**L28 - Boundary Updates - REF Area, Barry Way Road Upgrades, Jindabyne (Rev 0)**

**Review of REF Boundary Updates, Proposed Barry Way Road Upgrades, Jindabyne**

PROJECT  
JINDABYNE EDUCATION CAMPUS  
207 BARRY WAY JINDABYNE  
REVIEW OF ENVIRONMENTAL FACTORS

**Plate 1.1: Site boundaries of previously completed investigations, including JBS&G 2023 (purple), 2024a (purple), 2024b (red) and 2024c (green).**

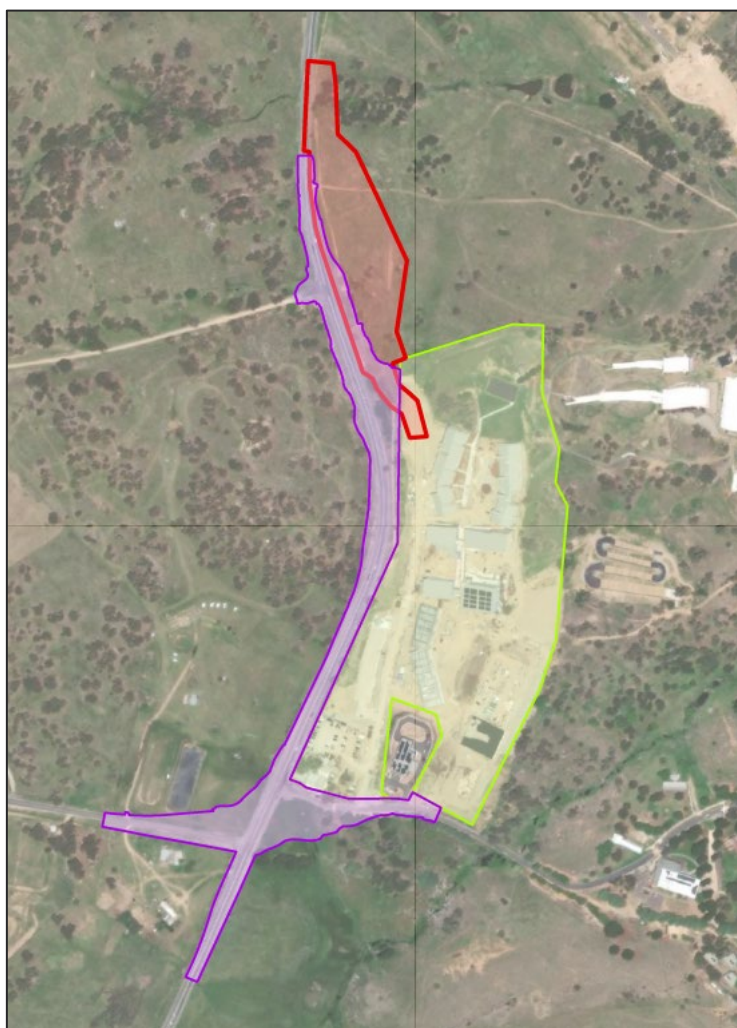
JBS&G has previously completed several contamination related investigations within the proposed Barry Way roadway upgrade area, including JBS&G (2023<sup>1</sup>), JBS&G (2024a<sup>2</sup>) and JBS&G (2024b<sup>3</sup>), to satisfy planning approvals requirements with consideration to *State Environmental Planning Policy (Resilience and Hazards) (2021)* and other guidelines made or endorsed by the NSW Environment Protection Authority (EPA). These investigations concluded that the sites were suitable, from a contamination perspective, for the proposed land use, in accordance with the Remediation of Land requirements of the SEPP Resilience and Hazards 2021 and relevant Planning Guidelines (DUAP/EPA 1998). In addition, the Jindabyne Education Campus site was previously remediated and validated (JBS&G 2024c<sup>4</sup>) as suitable for the proposed secondary education landuse, pursuant to NEPC (2013). The site boundaries as defined in the previously completed investigations are outlined in **Plate 1.1**.

DRAWING NAME  
GENERAL ARRANGEMENT PLAN

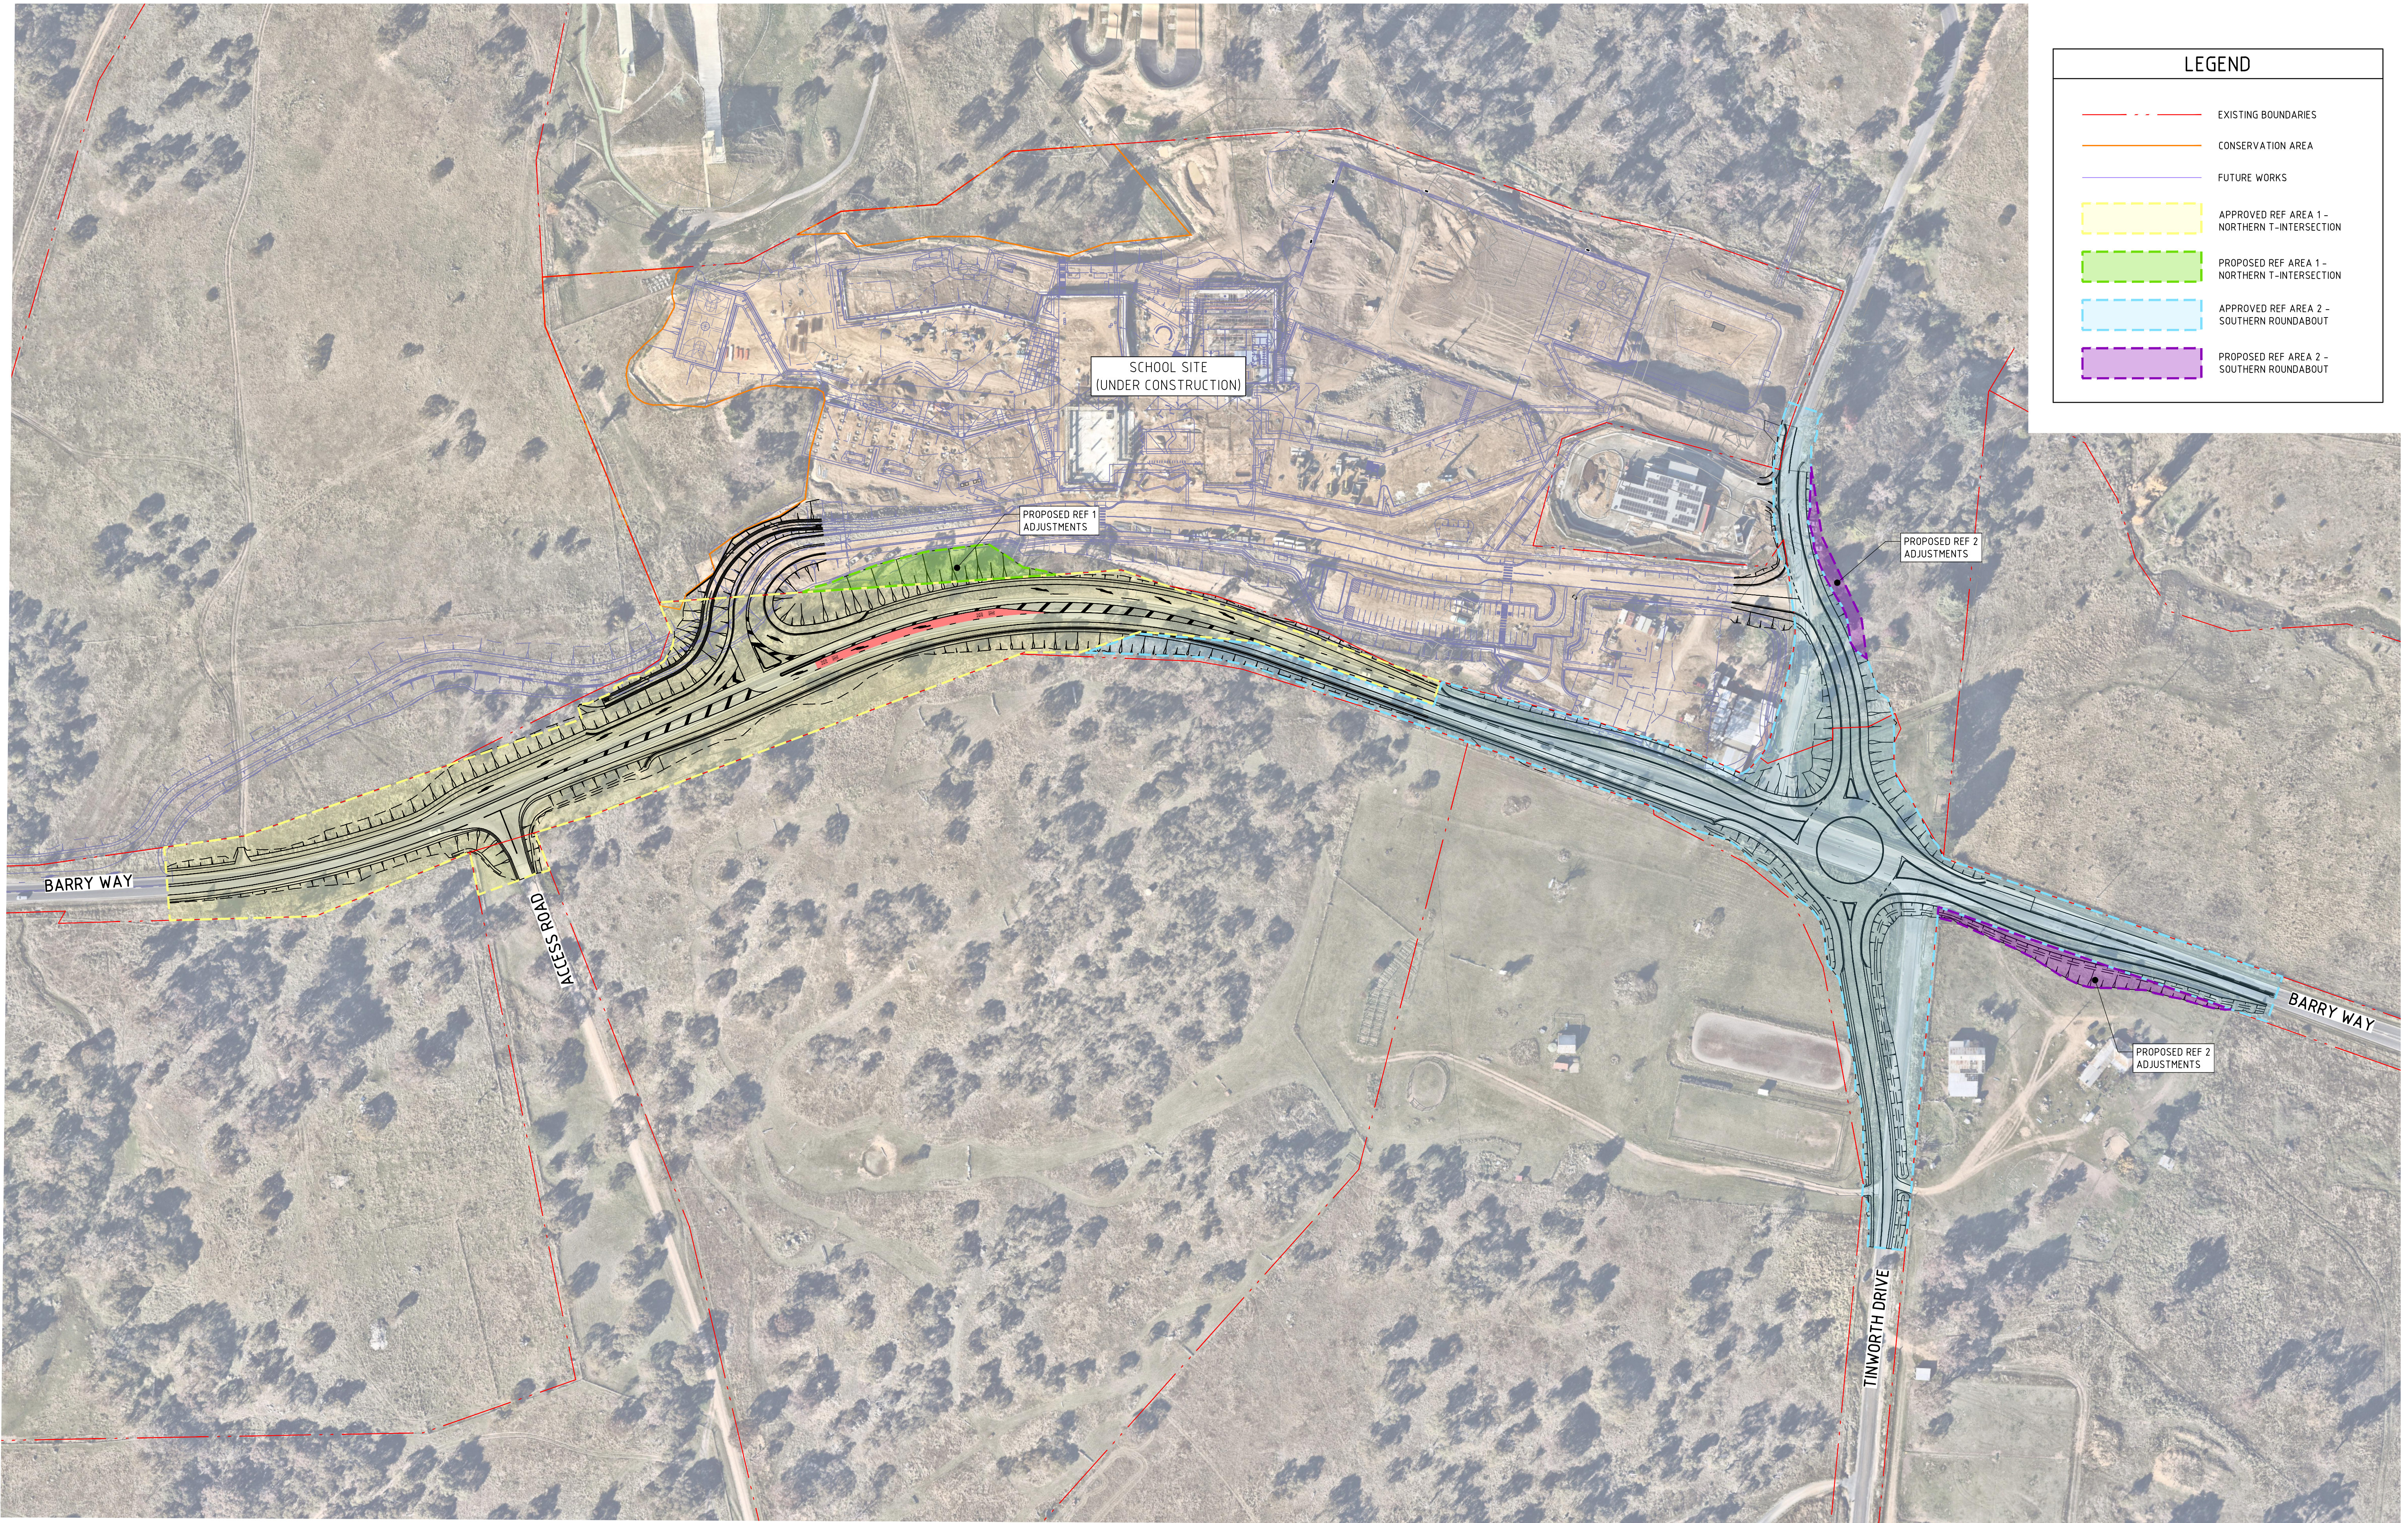
With reference to the general arrangement plan provided in **Attachment 1**, 'proposed REF Area 1' is located within the site boundary of JBS&G (2024c) and is therefore considered suitable for secondary education landuse, as well as less conservative landuses including roadways, which are categorised as commercial/industrial landuse, pursuant to NEPC (2013).

With reference to the extent of the 'proposed REF Area 2', this area is located immediately south of the JBS&G (2024a and 2024c) assessment areas. Review of historical aerial photographs, site history and observations made during previous investigations/inspections indicate that the 'proposed REF Area 2' extends into undisturbed terrain and is considered very-low risk for in-ground contamination.

As such, JBS&G consider that the findings of previous investigations provide sufficient information to demonstrate the suitability of the addendum REF Areas for the proposed landuse, in accordance with the Remediation of Land requirements of the SEPP Resilience and Hazards (2021) and relevant Planning Guidelines (DUAP/EPA 1998).
